RE: #05ITB45467K-RS  
SW Arts Performance Theater

**#05ITB45467K-RS, SW Arts Performance Theatre  
Addendum No. 2  
August 15, 2005  
Page Two**

**SW Arts Phase II**  
**ITB No. 45467K-RS**  
**Addendum 2**  
**8/15/2005**

SHEET NO.  
**SK28**

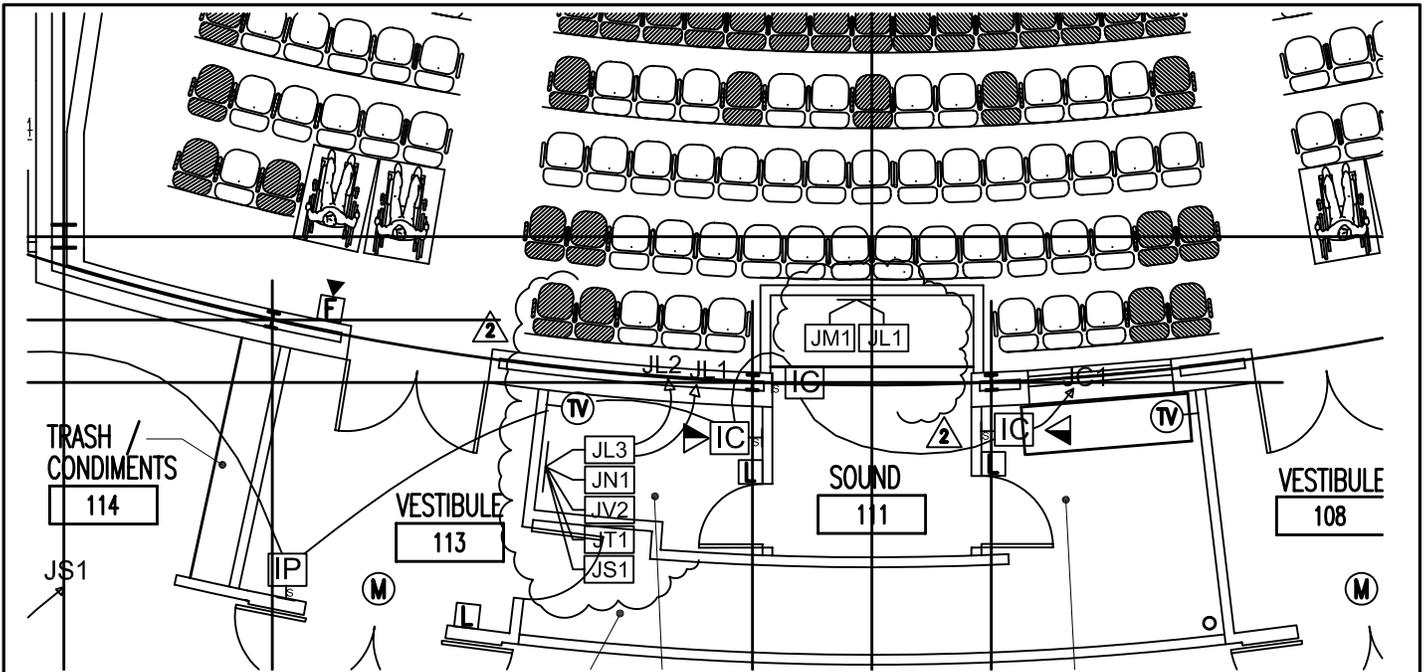
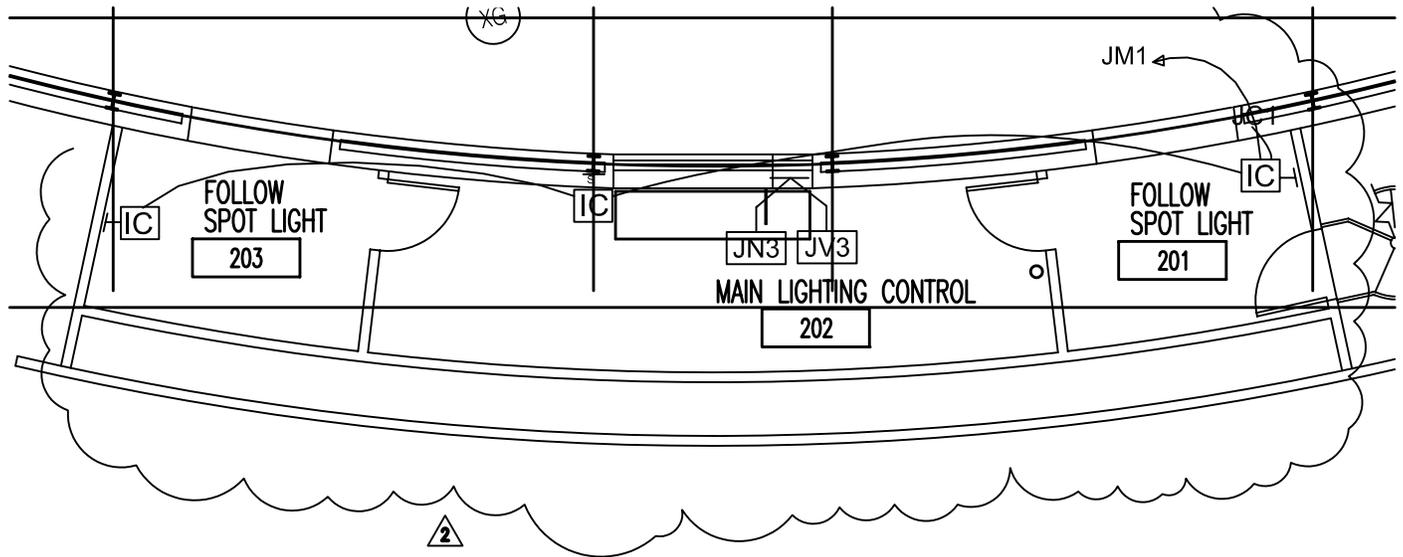
9. Clarify stage box types on drawing E4  
See SK28.
10. Clarify note locations on drawing AV2.1  
See SK30, SK31, SK32, and SK33
11. Add plate details to sheet AV4.1  
See SK34 and SK35.

SHEET NO.  
 SK29

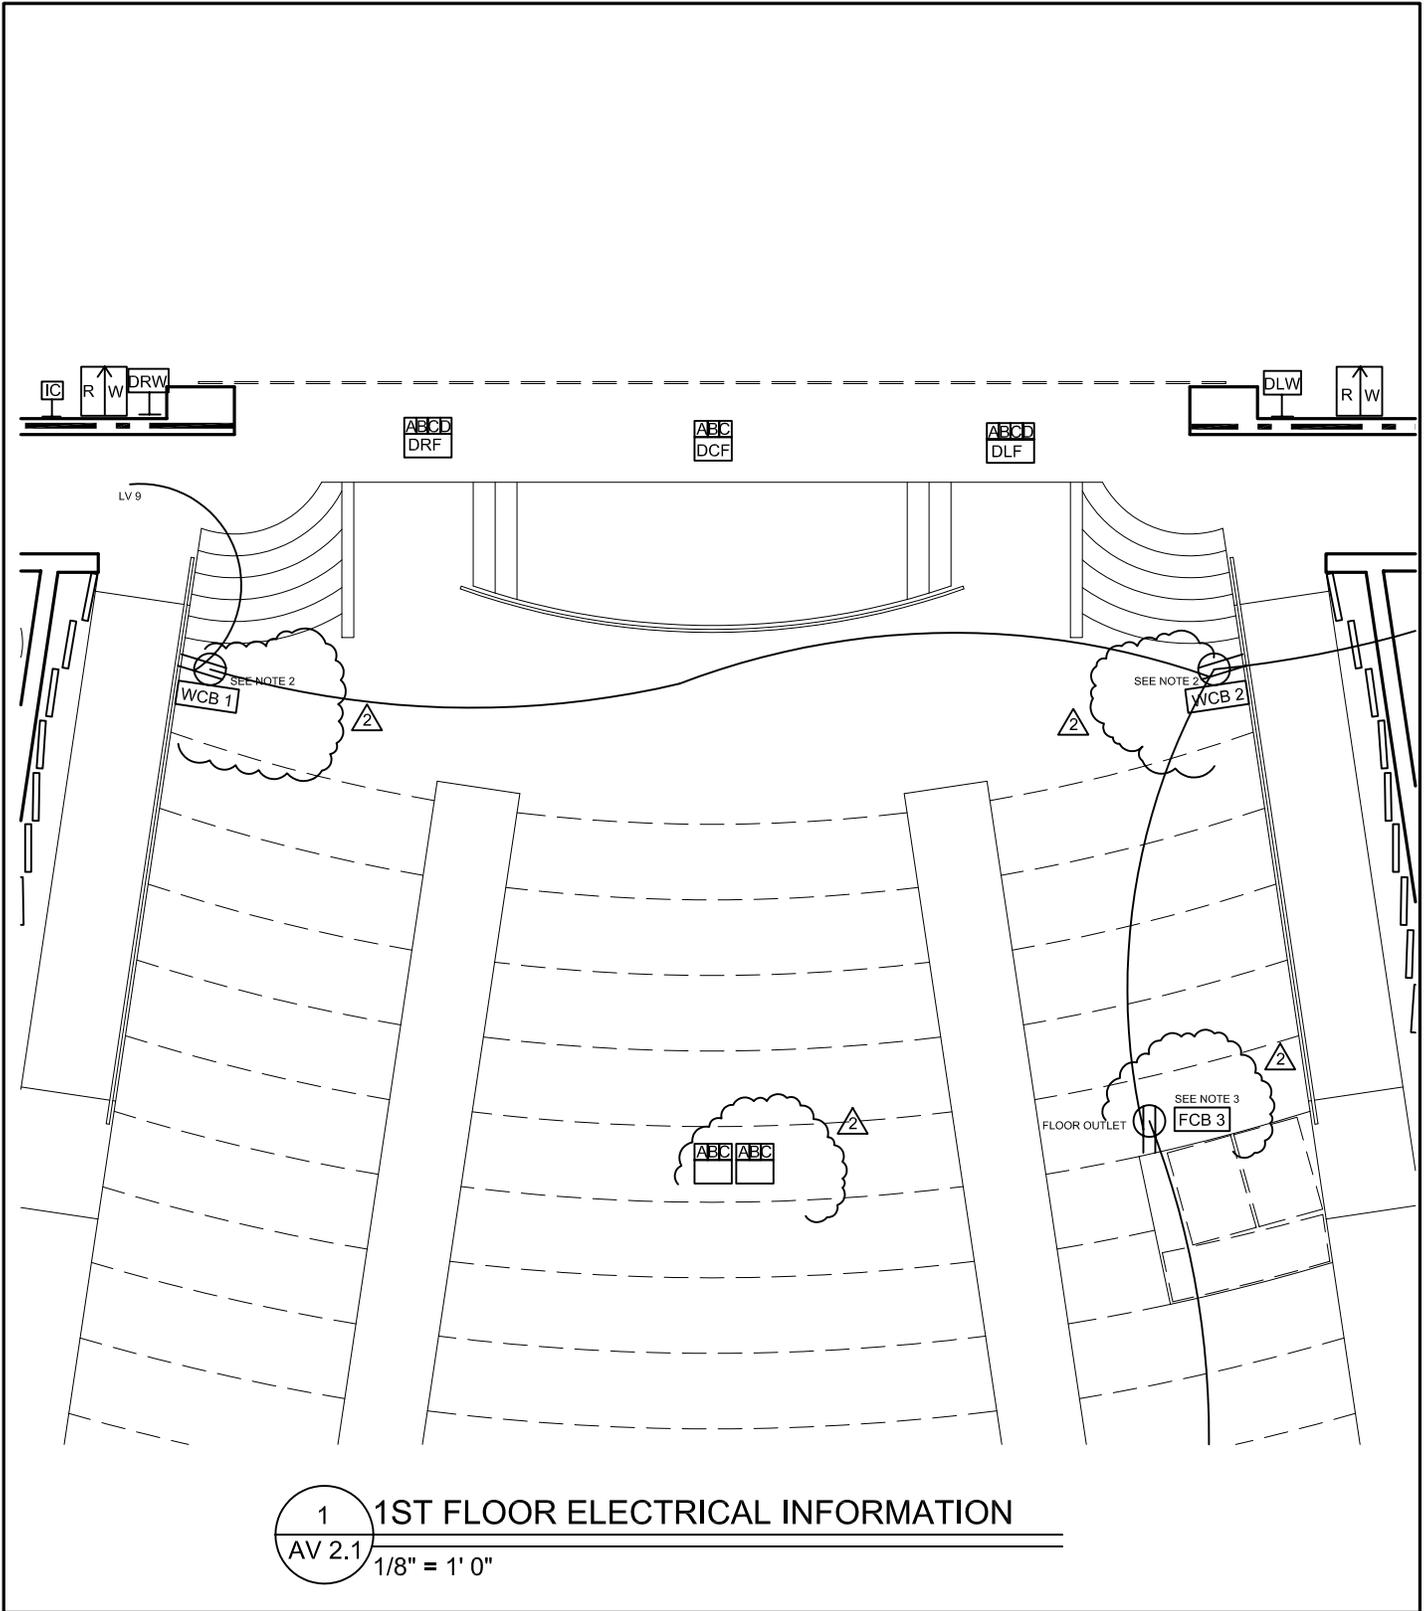
3. *The electrical drawing E4 shows a number of stage and wall boxes installed by the electrical contractor for audio-visual use. Several of these require the installation of conduit from these boxes to other boxes that do not appear to be located on either the electrical or audio-visual drawings. These boxes are JM1, JN1, LN3, JL3, JV2, JV3, and JL1. Please clarify.*  
See SK28 and SK29 for the locations of the terminations JL3, JN1, JV2, JT1, JS1 (all in space 112); JM1 and JL1 (all in space 111); and JN3 and JV3 (all in space 202). These terminations then are connected to floor racked equipment.

PROJECT NAME	PROJECT NO.	DATE	SHEET NO.
FULTON COUNTY	01145	08-05-05	SK30
SW ARTS			
PHASE II THEATER			
SHEET TITLE	REF. SHT.	REVISION	SCALE
DEVICE LOCATIONS: 1ST	AV2.1	Addendum 2	1/8" = 1'-0"
FLR. & MEZZANINE	E2

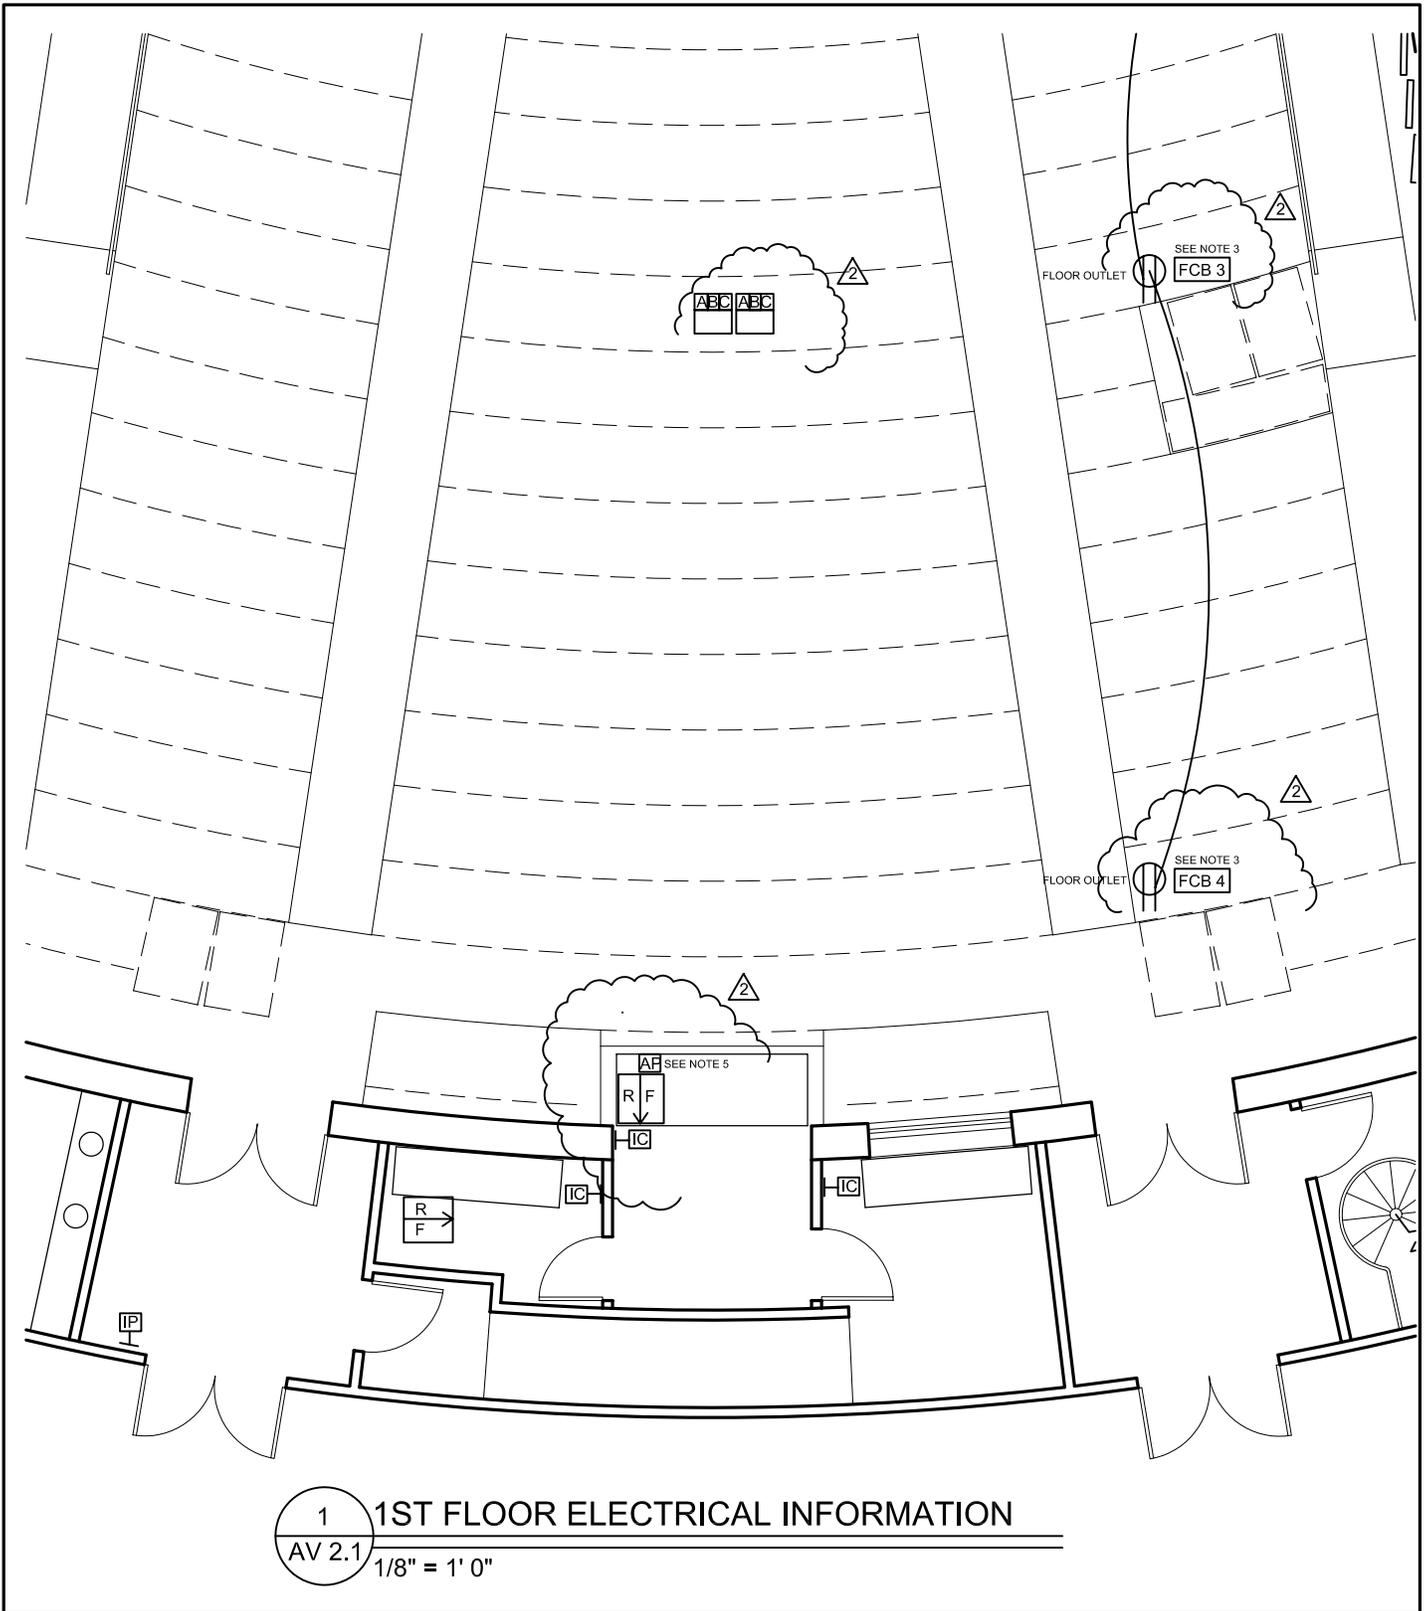
6. *Drawing TH9.0 schematic layout shows a rehearsal floor box which does not appear to be located on the floor plan drawing TH12.0 Is this floorbox required? Where is it located and what size and type?*  
Yes, the Rehearsal Floor Box is required and is located as indicated on SK30. The size is scheduled as FB-2 (FSR-540P-BK).
